ADDENDUM NO. 1

CITY OF SAN ANTONIO CAPITAL IMPROVEMENTS MANAGEMENT SERVICES

PROJECT NAME:
MISSION TRAILS PACKAGE IV AND V
CSJ: 0915-12-438

DATE: June 21, 2012

| DRAWN: JML | JOB NO. 438 | SHEET NO. 335 | | |

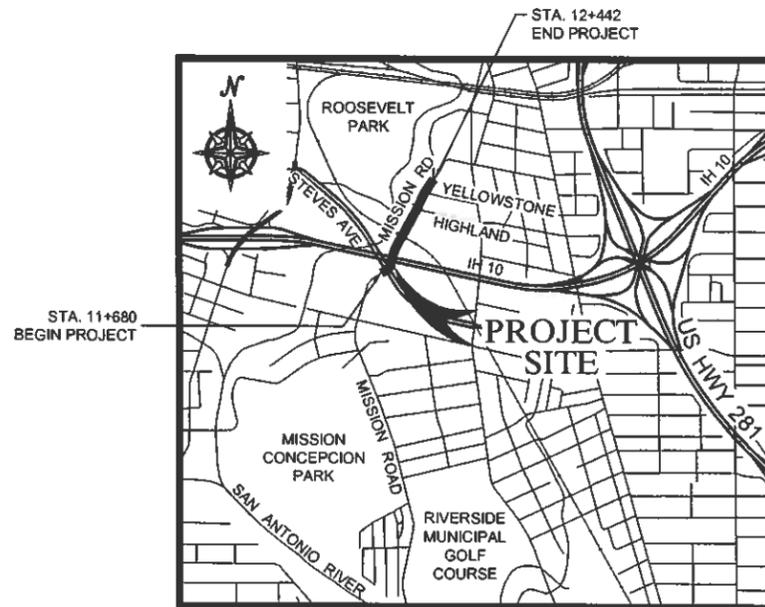
- 1. Revised Plan Sheet 19
 - a. revised to remove Item 8302
 - b. revised to add Item "LIQUIDATED DAMAGES"
 - 2. Revised SAWS Water Plan Sheet 335
 - a. Revised General Notes
 - 3. Revised SAWS Water Plan Sheet 336
 - a. Added Item 500 "PREP ROW"
 - b. Revised SAWS Water Item 9525 "REMOVAL, TRANSPORTATION AND DISPOSAL" Measurement from LS to Item 3000 "REMOVAL, TRANSPORTATION AND DISPOSAL" Measured by the M
 - 4. Revised SAWS Water Plan Sheet 342
 - a. Revised SAWS Water Item 9525 "REMOVAL, TRANSPORTATION AND DISPOSAL" Measurement from LS to Item 3000 "REMOVAL, TRANSPORTATION AND DISPOSAL" Measured by the M
 - 5. Revised SAWS Sanitary Sewer Plan Sheet 351
 - a. Revised General Notes
 - 6. Revised SAWS Sanitary Sewer Plan Sheet 352
 - a. Added Item 500 "PREP ROW"
-

| REVISIONS | | |
|-----------|-----------|-----------------------|
| 1 | 6/15/2012 | REVISED GENERAL NOTES |

| | | | SHEET NO. 336 |

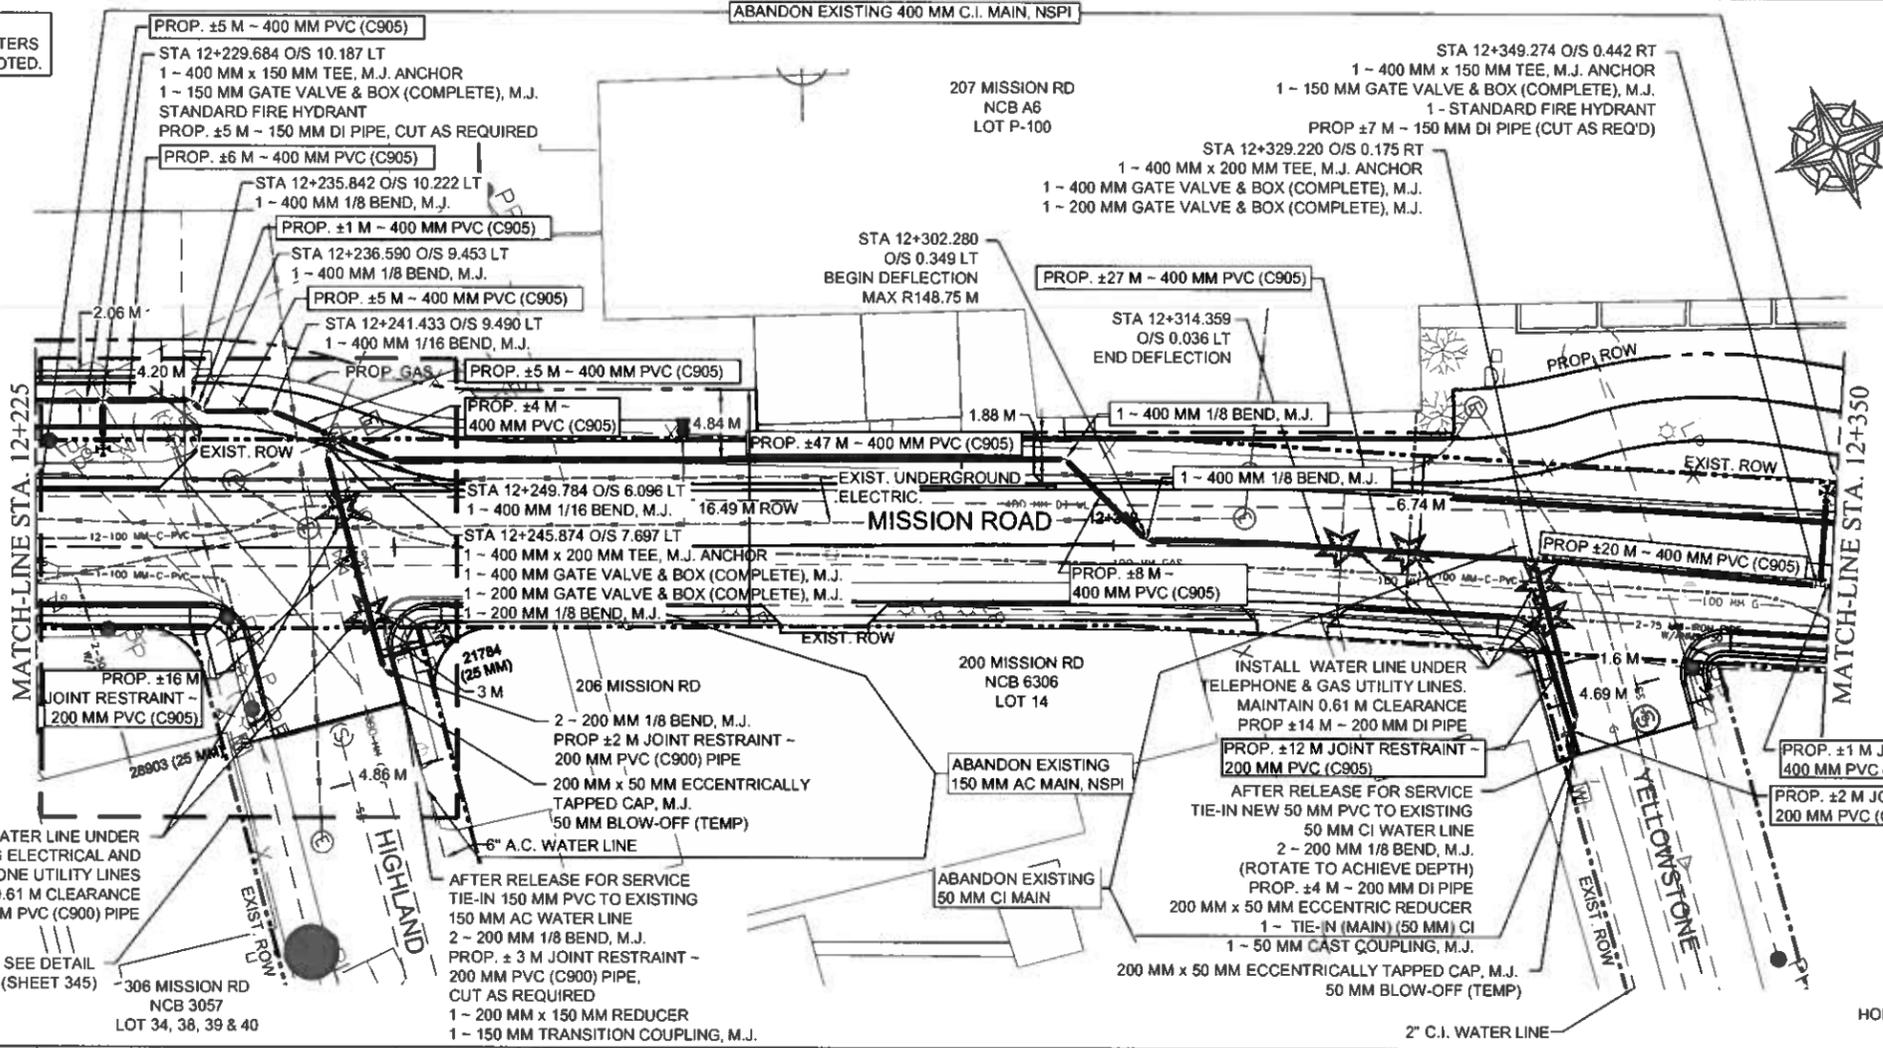
| REVISIONS | | |
|-----------|-----------|---|
| 1 | 6/15/2012 | ADDED PREP ROW AND CHANGED AC PIPE REMOVAL FROM LS TO M |

| DRAWN: JML | | | JOB NO. 438 | SHEET NO. 342 |

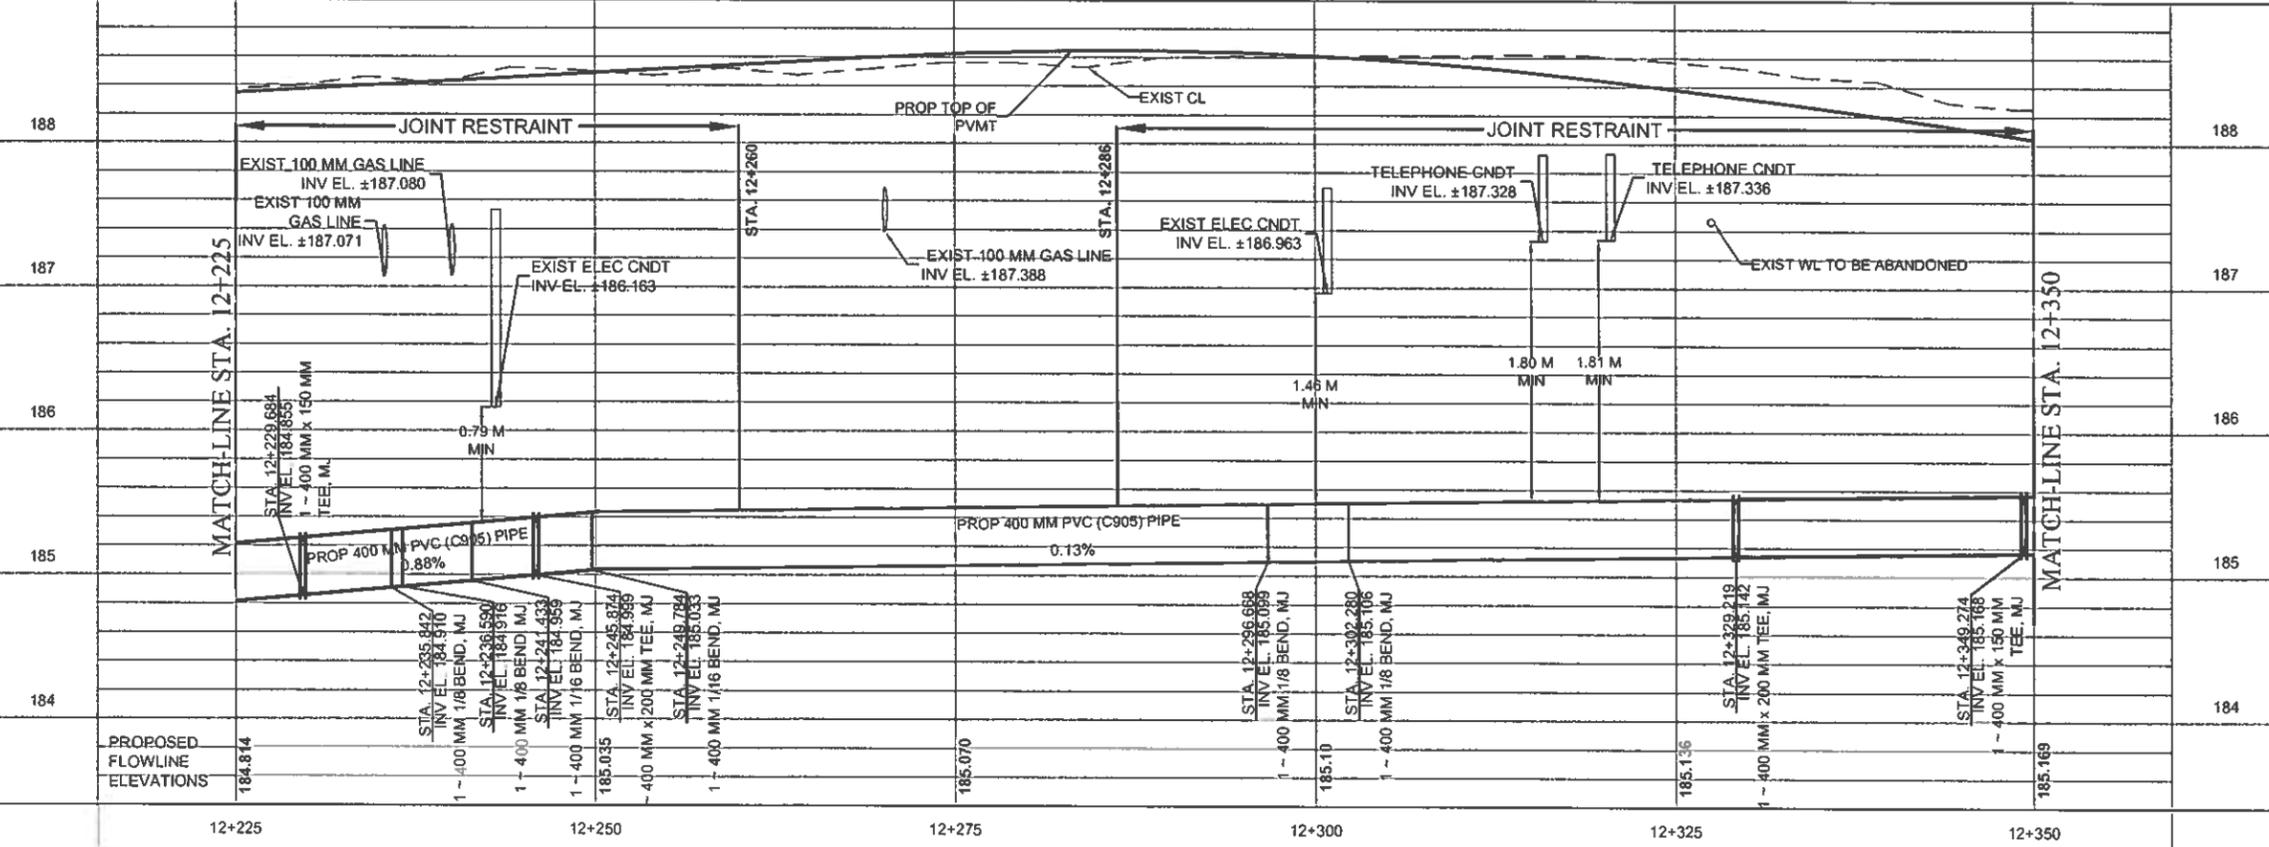
| REVISIONS | | | | |
|-----------|------------|---|--|------|
| 2 | 02/20/12 | REVISED ITEM NUMBER FOR AC PIPE REMOVAL | | |

| DRAWN: JML | JOB NO. 438 | SHEET NO. 351 | | |

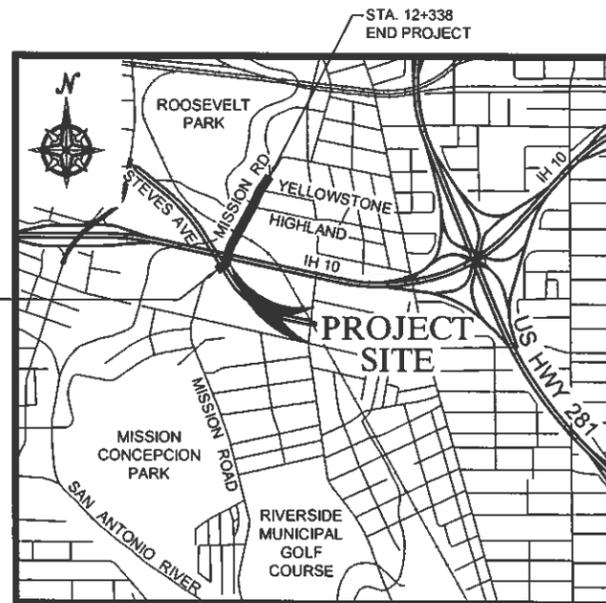
| REVISIONS | | |
|-----------|-----------|-----------------------|
| 1 | 6/15/2012 | REVISED GENERAL NOTES |
